AGENDA PORTLAND PLANNING BOARD MEETING

The Planning Board will hold a remote meeting on Tuesday, June 23, 2020, 4:30 p.m. This meeting will take place using Zoom.

To: Brandon Mazer, Chair, and Members of the Portland Planning Board
From: Christian Roadman, Planner
Date: June 19, 2020
Re: Cold Storage Facility, 40 West Commercial Street
Project #: PL-001042-2020 CBL: 059 A001
Meeting Date: June 23, 2020

GRADING & DRAINAGE PLAN – EXTERIOR

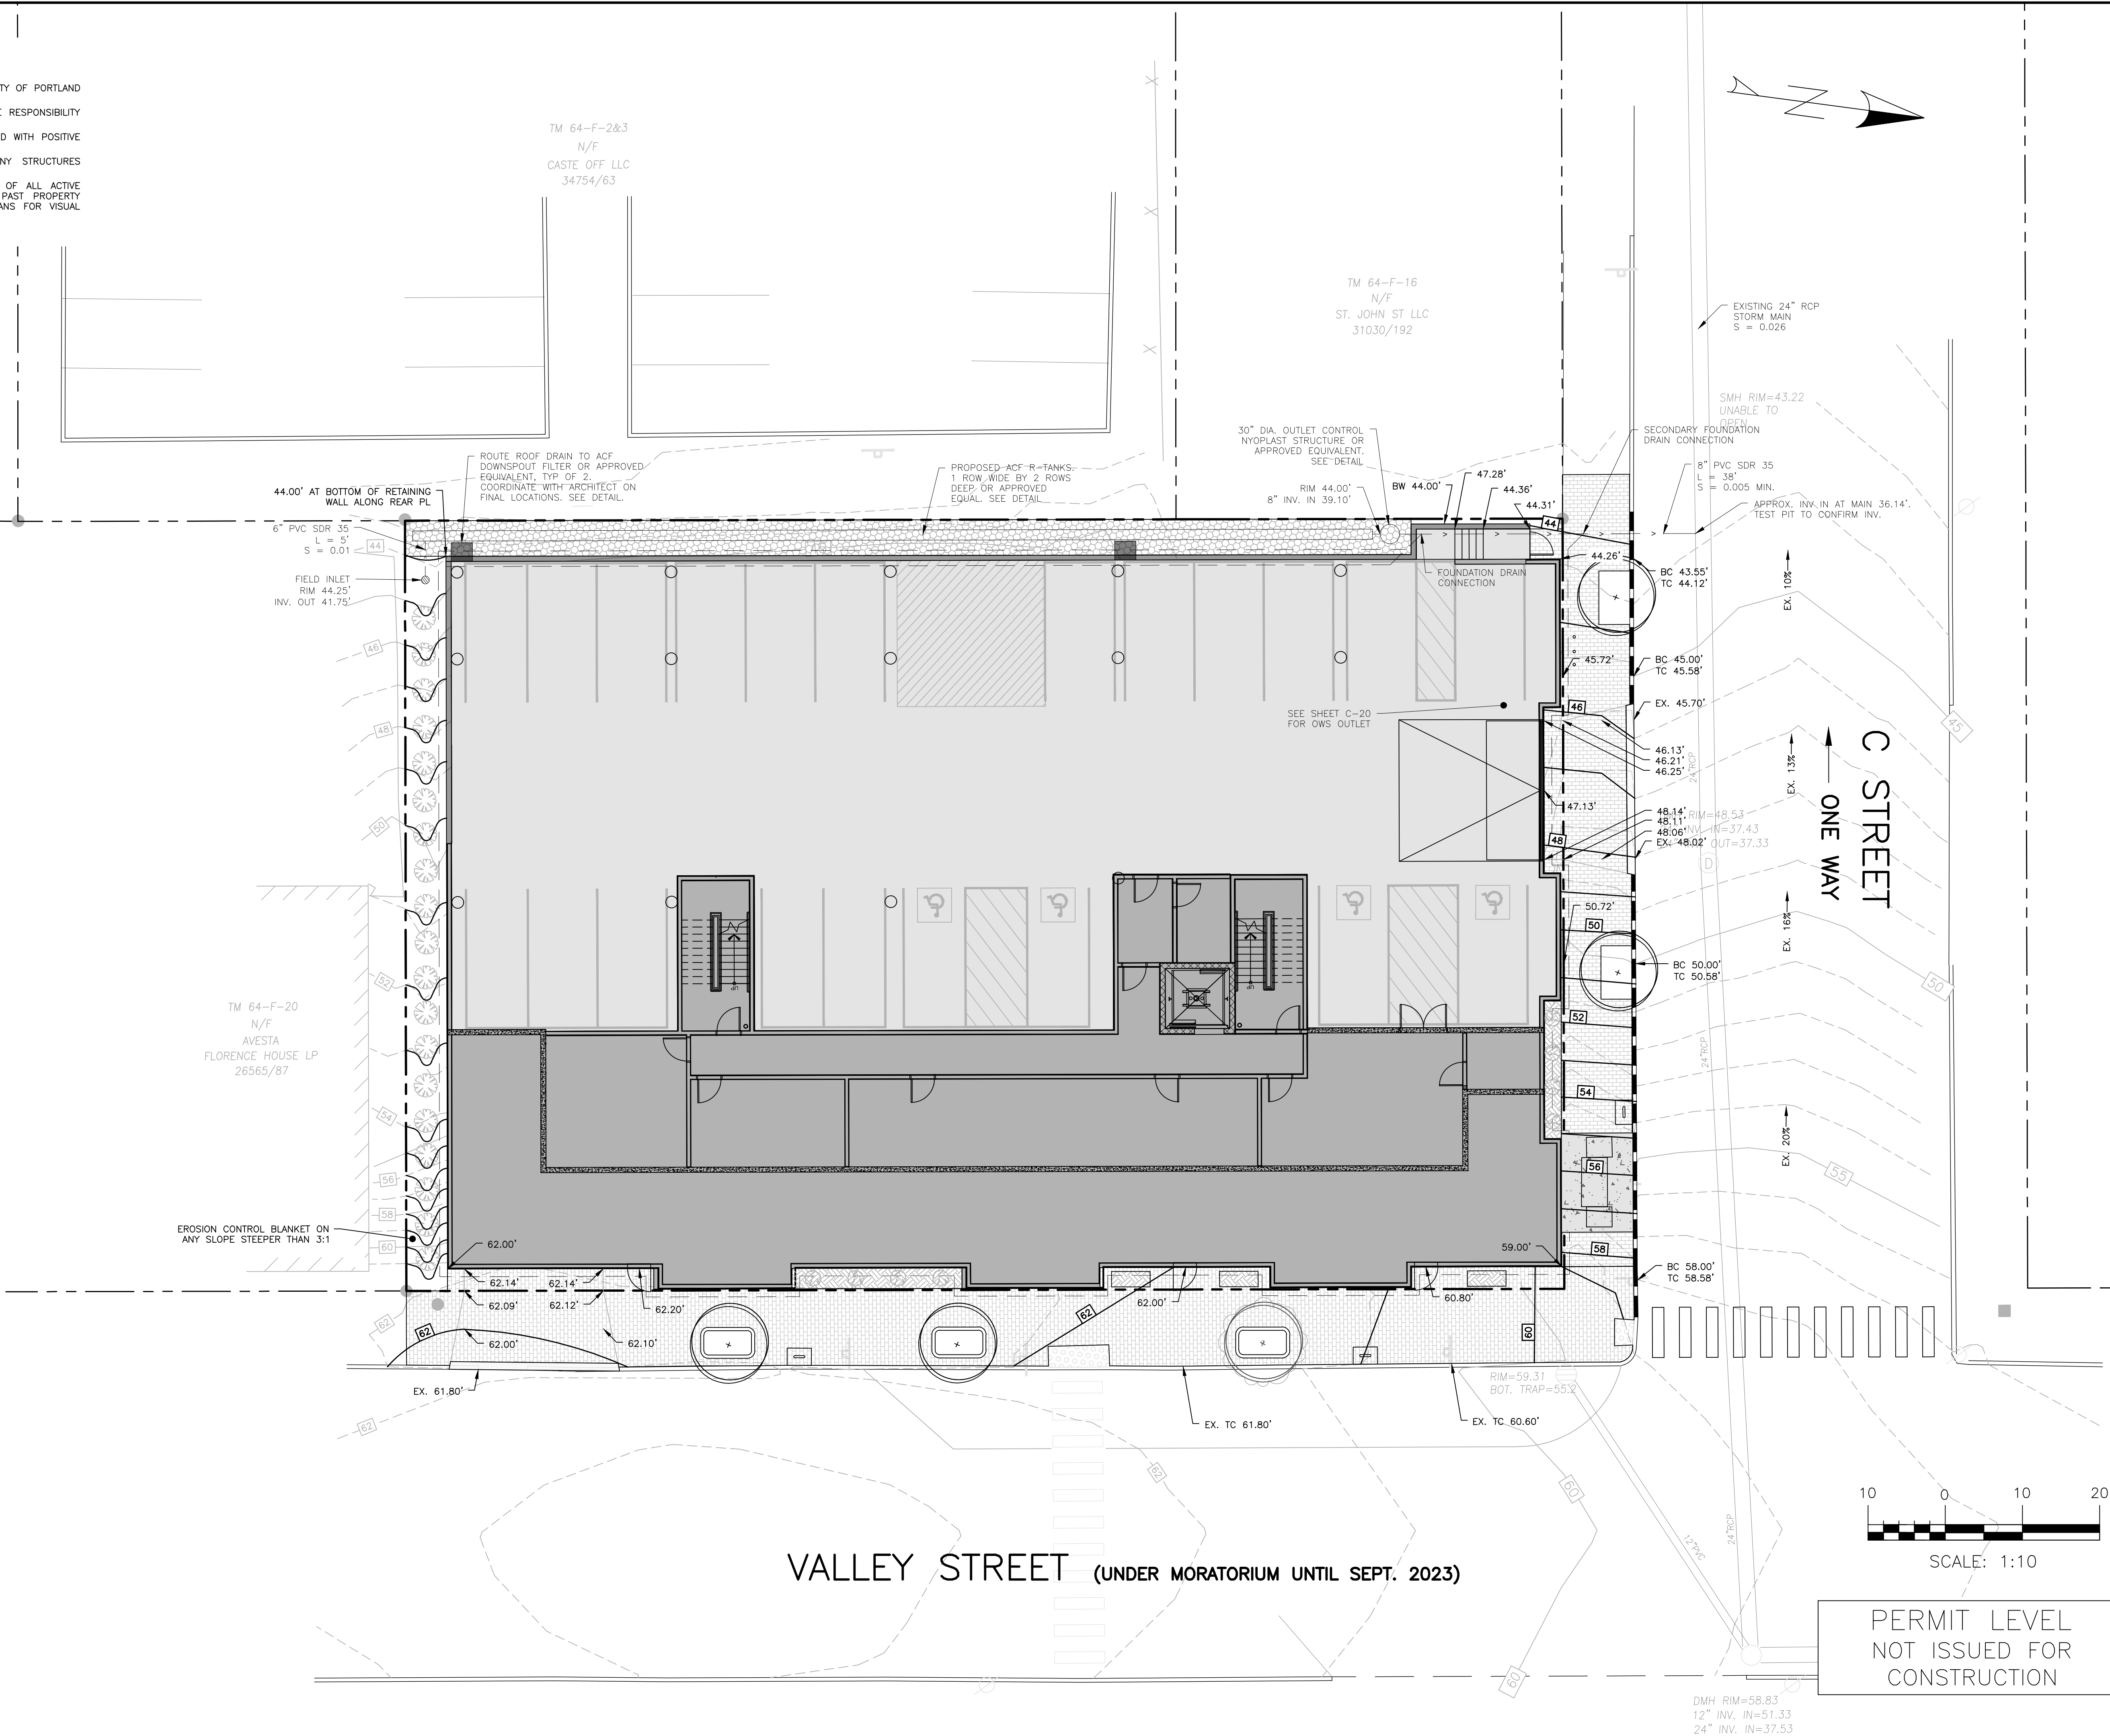
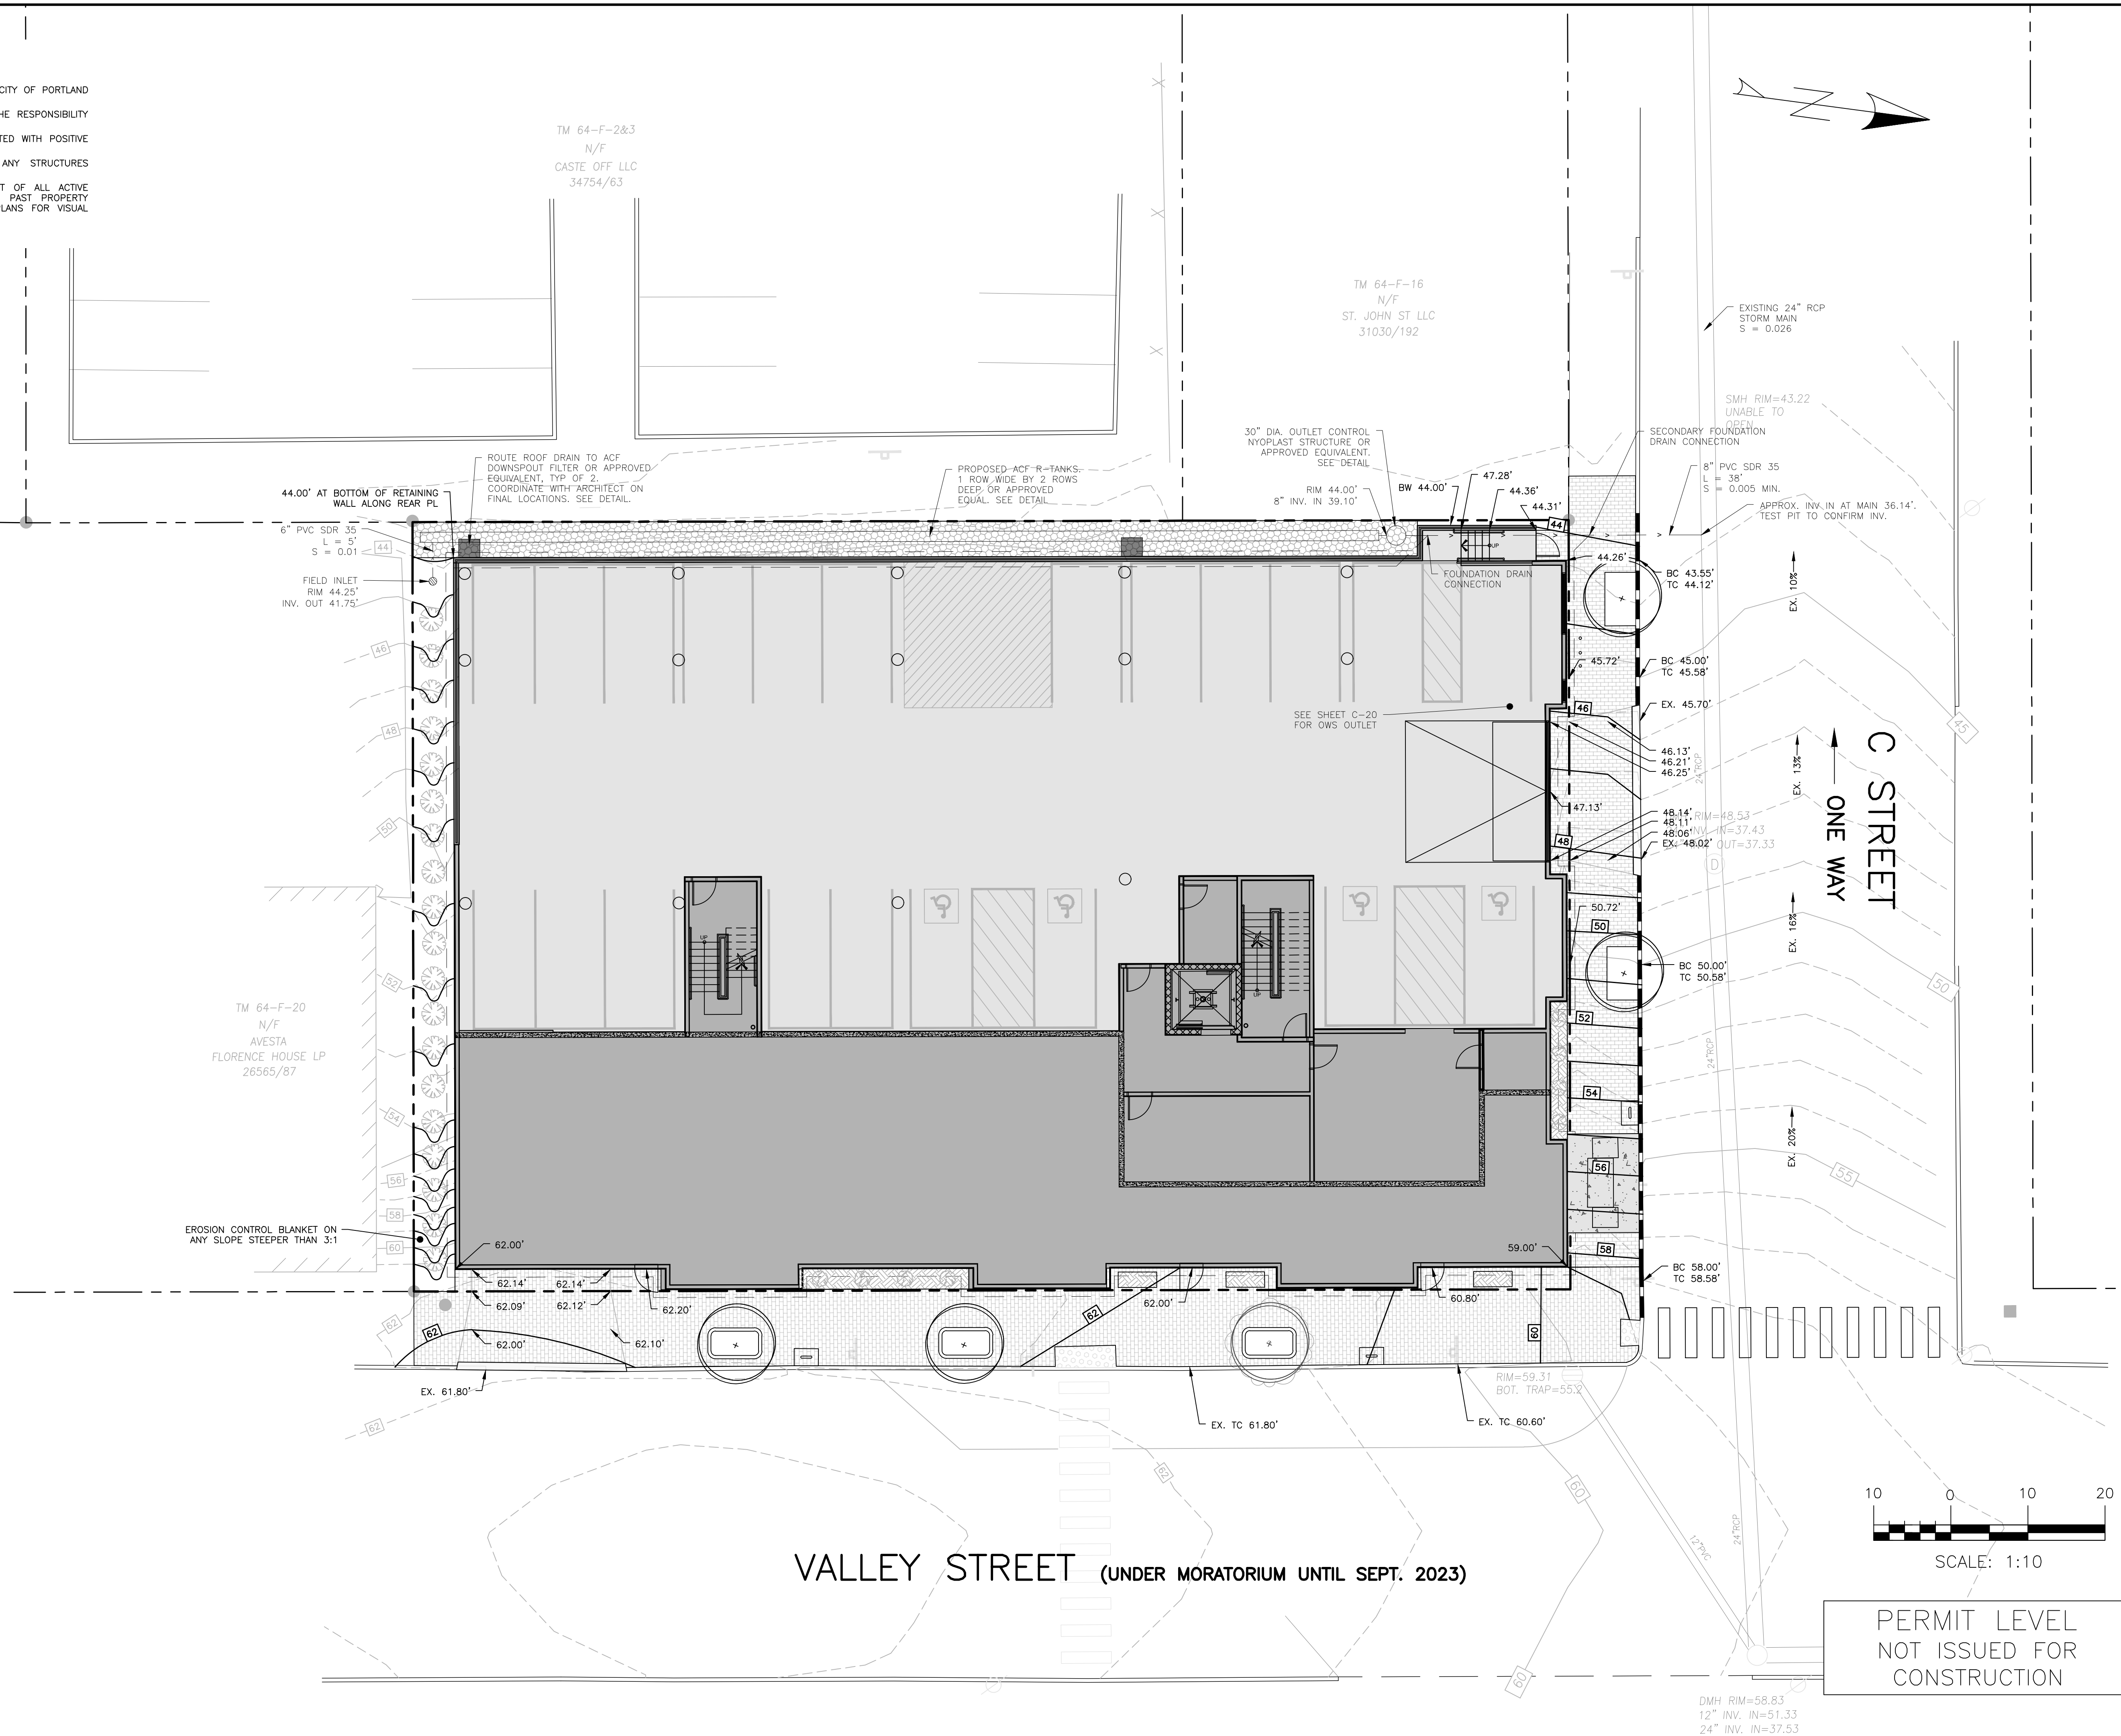
- Spot grades for the curb ramps along the site's frontage should be provided.
- Driveway aprons should be constructed using bugs, ramping up to sidewalk level, per the detail attached. The driveway detail used in Sheet C-40 should not be used.
